Value Engineering Study Report

Georgia Department of Transportation
STP00-00MS-00(005) - P.I. No. 550560
Whitfield Ave./SR 204 Spur
Old Whitfield Avenue to Ferguson Avenue
Chatham County

February 12, 2010

ALTERNATIVE NO.:
DR-1

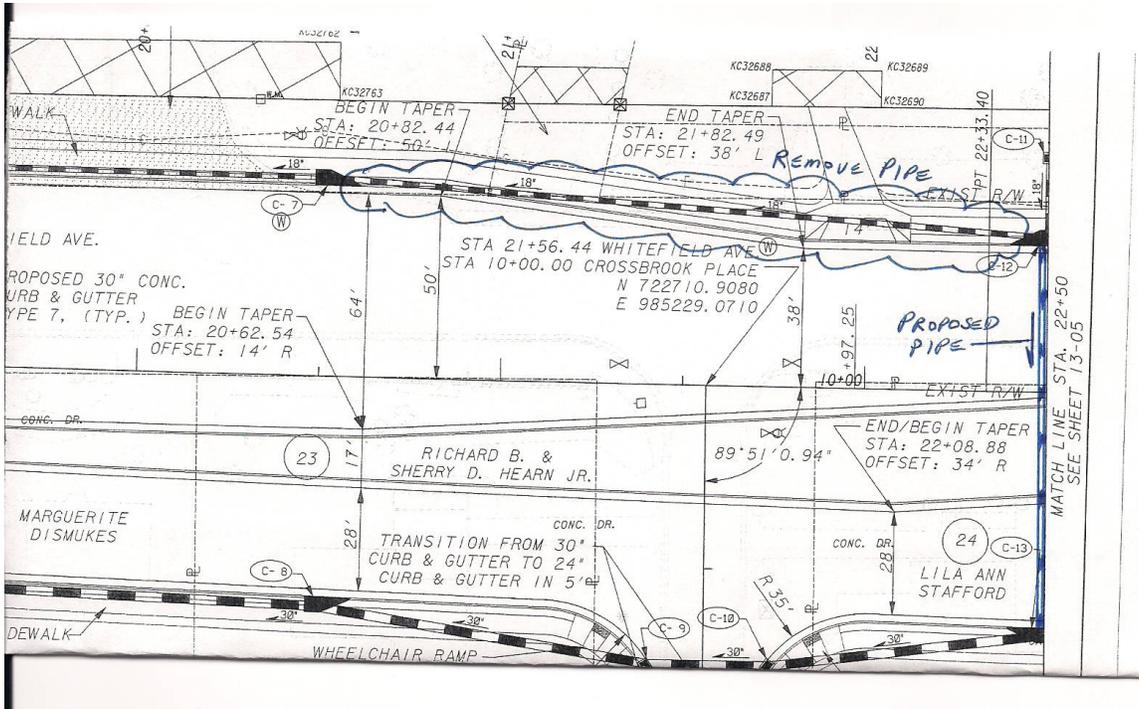
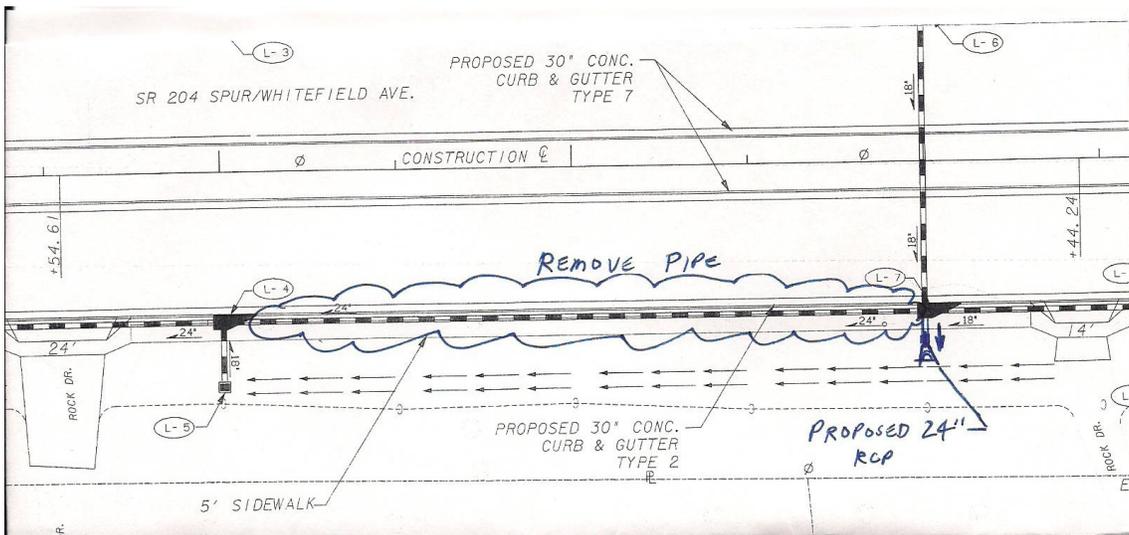
- A.) Connect G-10 to 30" storm drain pipe
- B.) Remove cross drain at Old Whitfield Ave.
- C.) Eliminate the manhole at A-5
- D.) Reroute piping as noted at 15+00, 17+00, 22+50 & 35+40 (See Illustrations on DR-02)
- E.) Use available open ditches to eliminate storm drain pipes at 8+30 Rt, 8+30 Lt, 76+80 Rt, 81+00 Lt, 81+00 Rt, 83+00 Rt, 83+00 Lt, 83+70 Rt & 85+00 Rt. (See Illustrations on DR-02)

Items A, B, C and D are Alternative Design recommendations associated with routing the closed systems to reduce the amount of required storm sewer piping needed within the closed systems. Item D will require additional open-cuts of the existing roadway. However these open-cuts are in close proximity to the locations of required open-cuts proposed in the Original Design and could be accomplished with minimal impacts to the M.O.T.

Item E is an Alternative Design to utilize required side ditches for drainage and eliminate parallel storm drain pipes. In many locations the Original Design requires a side ditch between the roadway and the R.O.W. to intercept runoff coming from offsite. The Original Design also requires closed systems to capture the street runoff. Designing both a side ditch and a storm drain pipe creates a dual drainage system. The storm drain pipe can be eliminated by making the side ditch deeper and discharging the street runoff directly into the side ditch. This is only viable when R.O.W. permits the construction of deeper side ditches.

ALTERNATIVE NO.:
RD-2

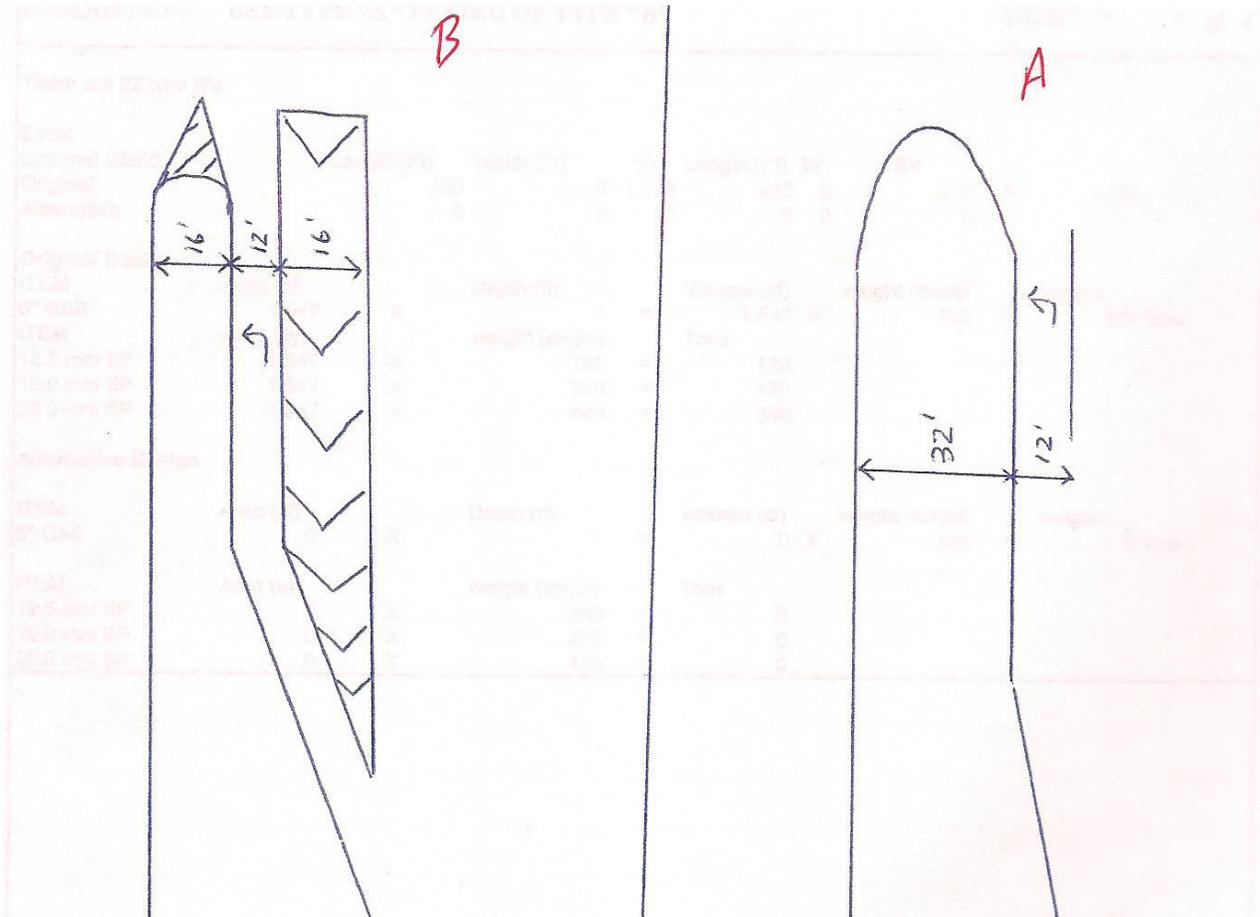
The original design proposes using Type "B" median turn lanes at the intersections of SR 204 and Lavon Avenue, Halcyon Drive and Grace Drive.

The alternative design proposes using Type "A" median turn lanes at the intersections of SR 204 and Lavon Avenue, Halcyon Drive and Grace Drive.

The GDOT Standards state that Type "B" median crossovers are the preferred type of median crossover; but that Type "A" median crossovers can be used as the situation may allow. Based on the Traffic Study information, using the Type "A" median crossovers should be acceptable. The roadway has little of no commercial development, flat terrain and relatively low truck traffic volumes (5 %) so sight obstructions at the intersections should be minimal. The intersections at Lavon Avenue and Grace Drive have low traffic volumes, 300 vpd (2033) and 1400 vpd (2033) respectively. The intersection at Halcyon is signalized. Also, using the Type "A" median crossover, the majority of the traffic should be able to make "U" turns without requiring "eyebrows" and accommodate larger vehicles.

ALTERNATIVE NO.:
RD-12

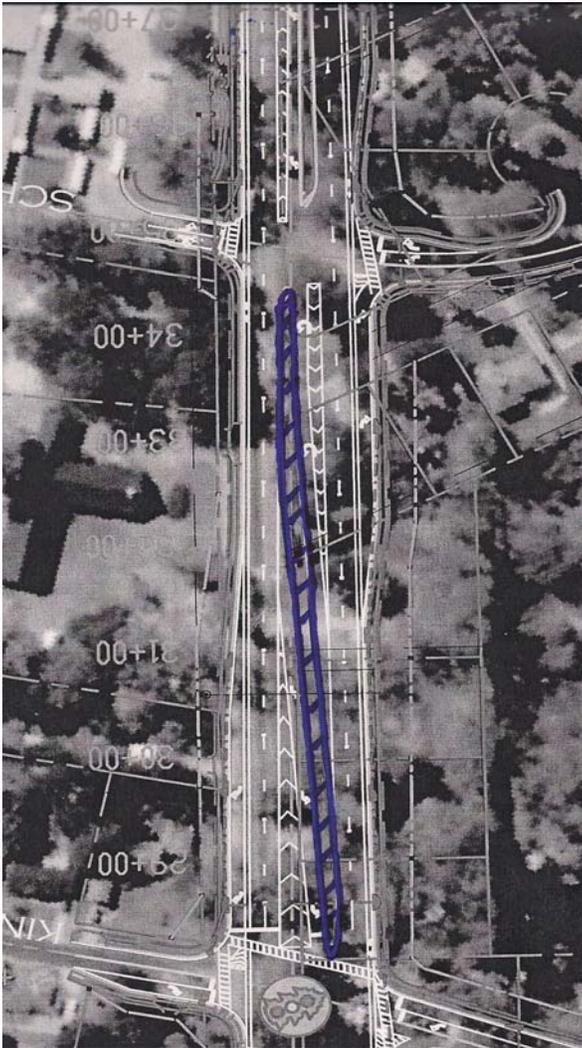
The original design proposes construction of a U-turn bay at Station 34+75 +/-.

The alternative design proposes eliminating the U-turn at Station 34+75 +/-.

The U-turn at Station 34+75 +/- appears to serve solely Saint Luke’s United Methodist Church. Installation of this U-turn will introduce potential conflicts with School traffic and may encourage motorist to attempt to enter the school’s exit only driveway. Traffic wanting to U-turn for Saint Luke’s United Methodist Church could utilize the median opening and left turn bay for Old Montgomery Drive.

ALTERNATIVE NO.:
RD-16

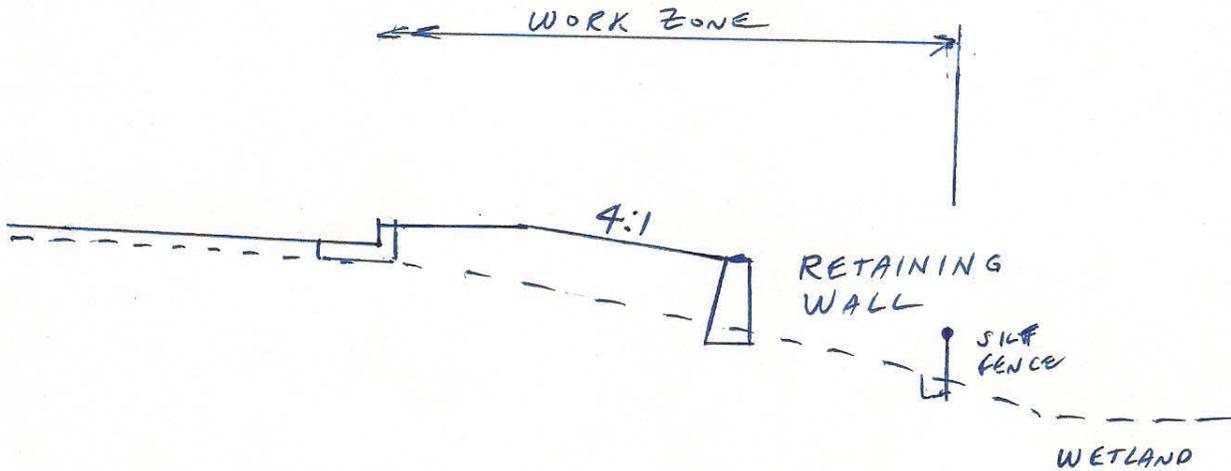
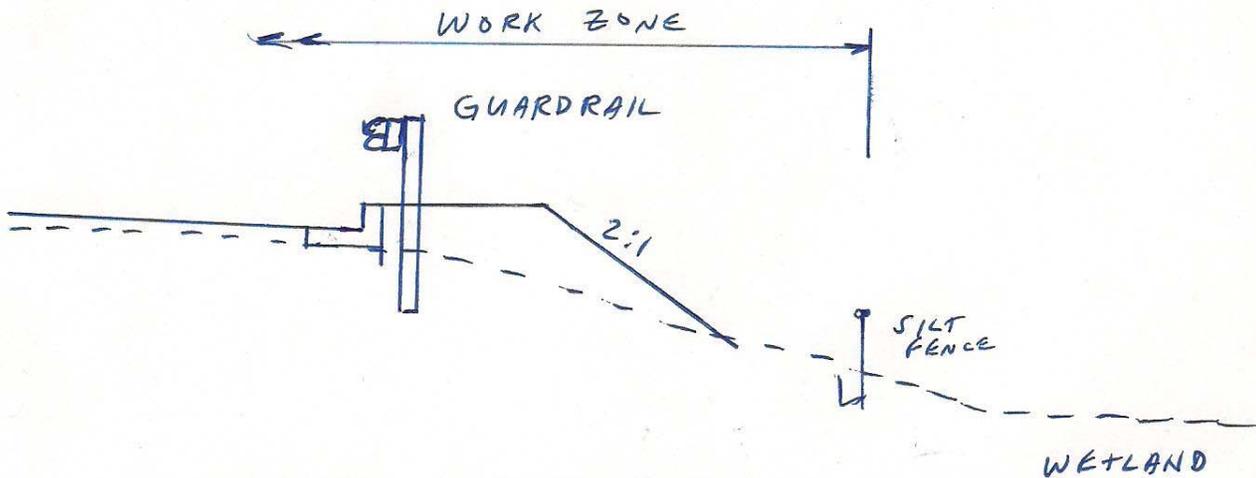
The original design requires retaining walls from 5+00 to 7+25 left and 6+00 to 7+25 right.

The alternative design would eliminate the retaining walls and provide guardrail with 2:1 front slopes.

In the Original Design, it appears the retaining walls are within the clear zone as defined by the Roadside Design Guide. As such the retaining walls must be moved, protected or eliminated. It appears moving the retaining wall outside of the clear zone puts the work area into the wetland area. Leaving them located as presently shown would require protection. The obvious method to protect the retaining walls is to extend the guardrail from the bridge approaches. Providing guardrail, allows for 2:1 front slopes, which appears to avoid wetland encroachments. The Alternative Design proposes to provide guardrail with 2:1 front slopes (to stay out of the wetland area) and eliminate the retaining walls.
